**Before the
FEDERAL COMMUNICATIONS COMMISSION
Washington, D.C. 20554**

_____)	
In the Matter of)	
)	
SPACE X SERVICES, INC.)	IBFS File Nos. SES-LIC-20190816-01062
)	and -01063; SES-LIC-20190827-01110; and
Applications for Ka-band Gateway)	SES-LIC-20190906-01170 and -01171
Earth Station Authorizations)	
_____)

RESPONSE OF SPACE X SERVICES, INC.

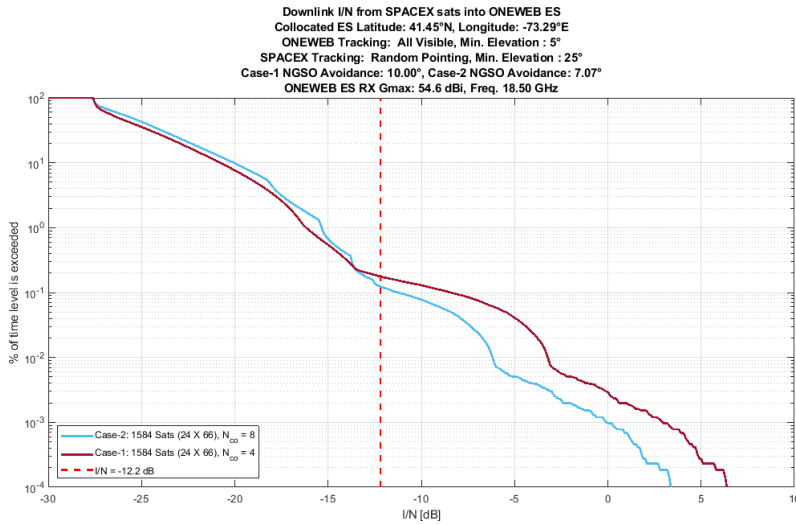
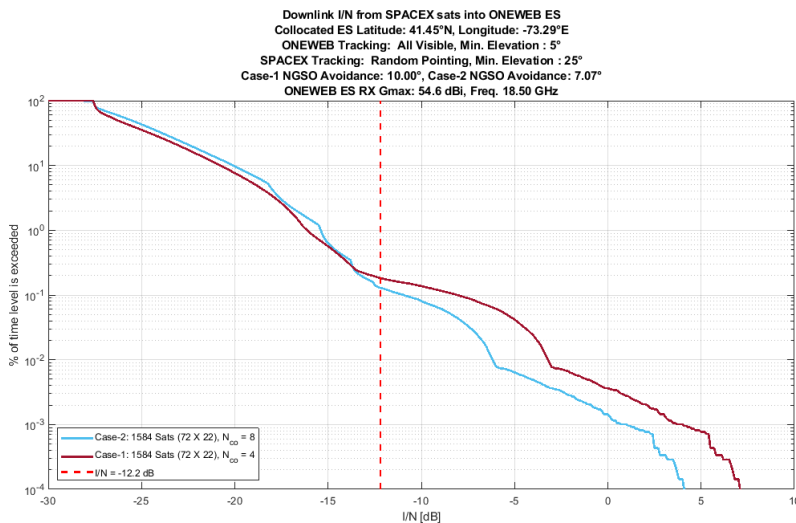
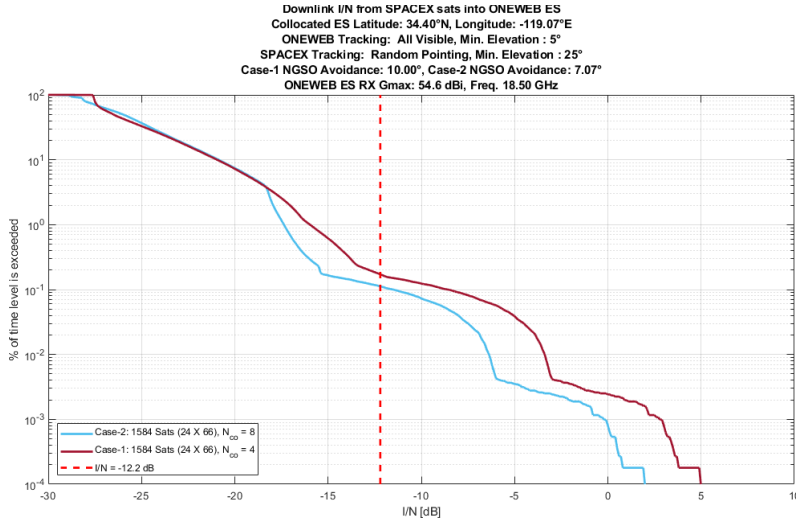
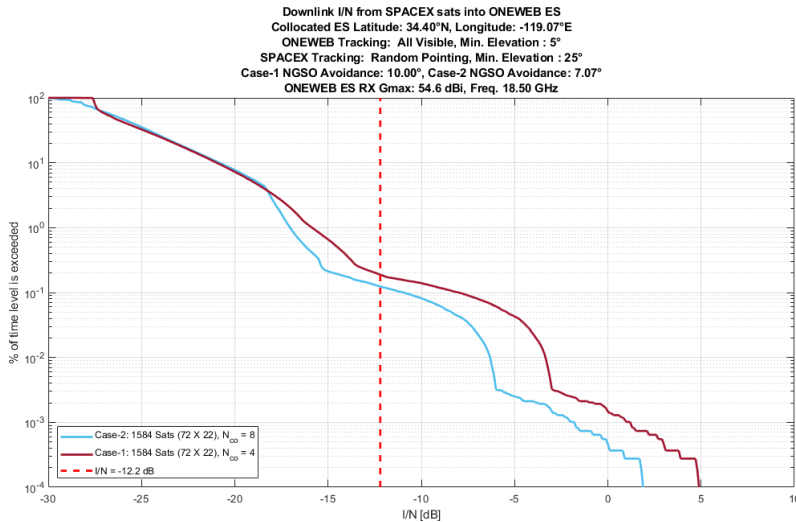
As these figures illustrate, there is no overall increase in interference to OneWeb’s collocated gateway earth stations in the region of the figure where in-line events occur (i.e., where $I/N > -12.2$ dB). Those occasions where I/N is slightly higher for eight satellites rather than four all occur in the region where $\Delta T/T < 6\%$ – i.e., where there is no in-line event with either four or eight satellites. Accordingly, those very slight exceedances have no material impact on spectrum sharing among NGSO systems.

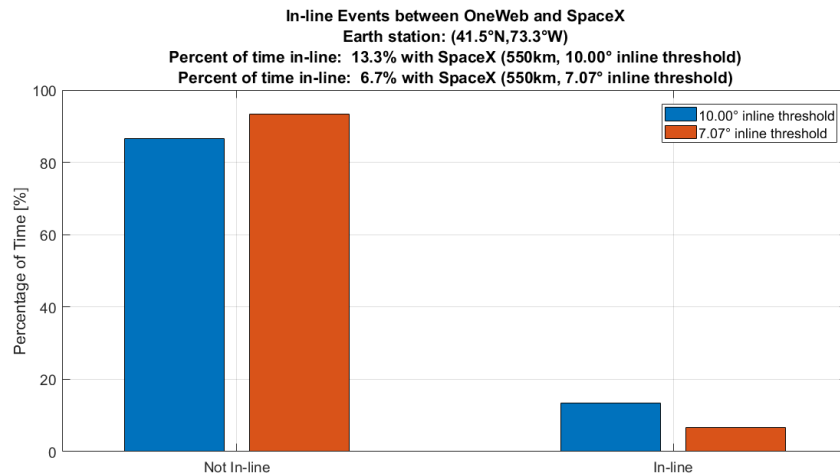
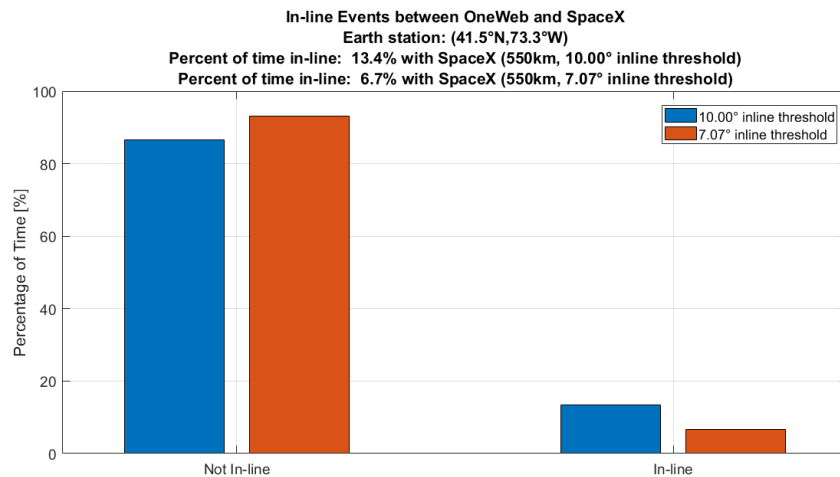
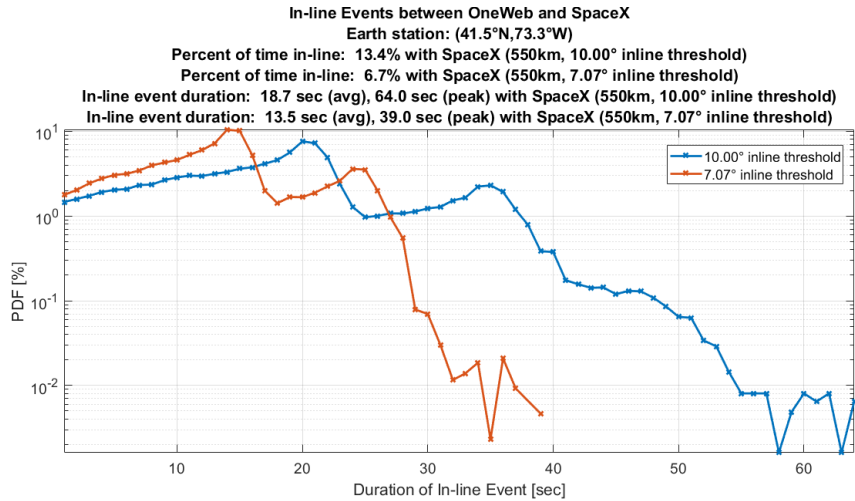
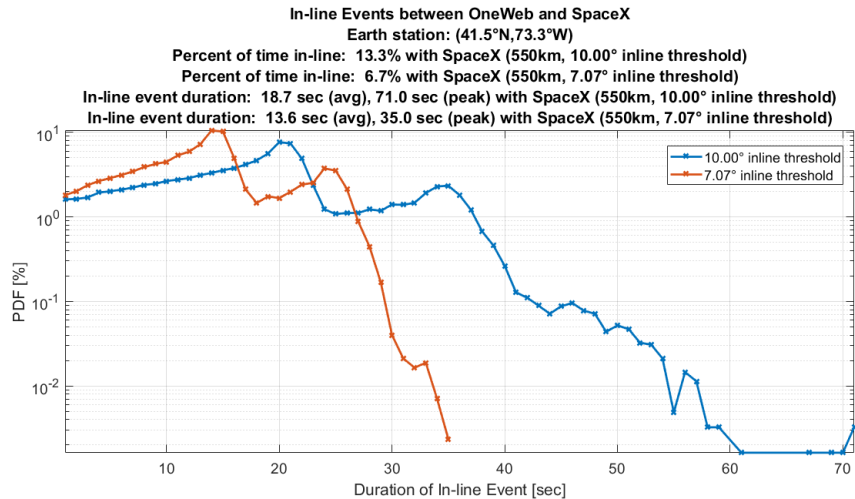
Figures 5 through 8 below show the in-line events from the perspective of OneWeb’s highest elevation satellite (used as an example for gathering statistics in the simulation) to the Southbury, CT site for the SpaceX constellation as currently authorized and as modified. As the figures show, the number of in-line events and their maximum and average duration are significantly reduced when switching from $N_{co} = 4$ to $N_{co} = 8$.

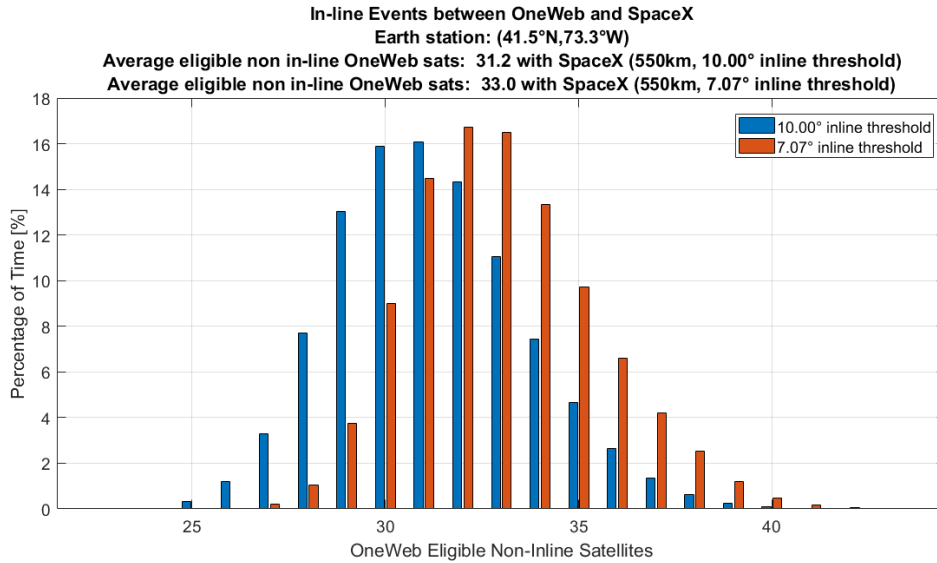
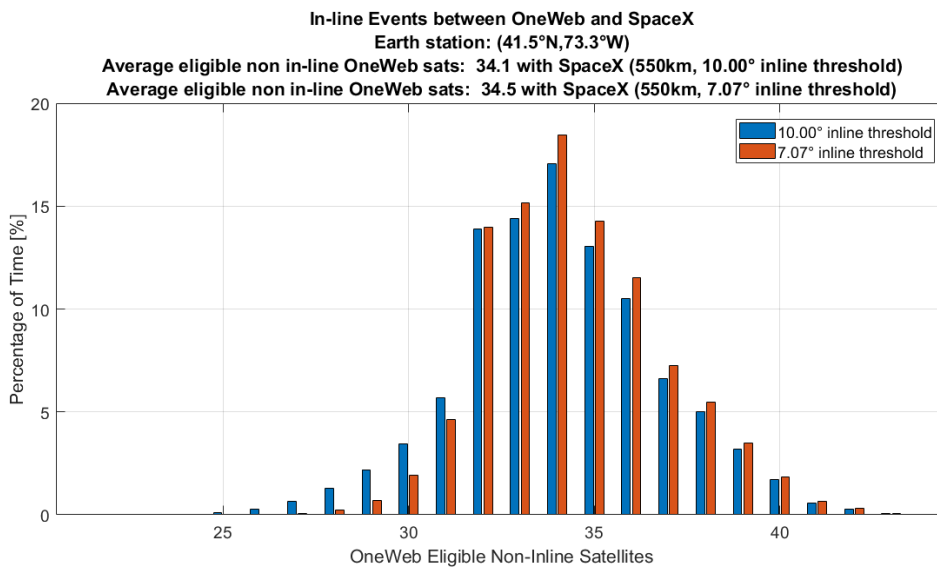
Figures 9 and 10 below show the number of OneWeb eligible satellites (i.e., over 5 degrees minimum elevation, over 6 degrees from the GSO arc, not in-line with a SpaceX satellite) from the perspective of OneWeb’s Southbury, CT earth station. As the figures show, the number of eligible satellites actually increases when switching from $N_{co} = 4$ to $N_{co} = 8$.
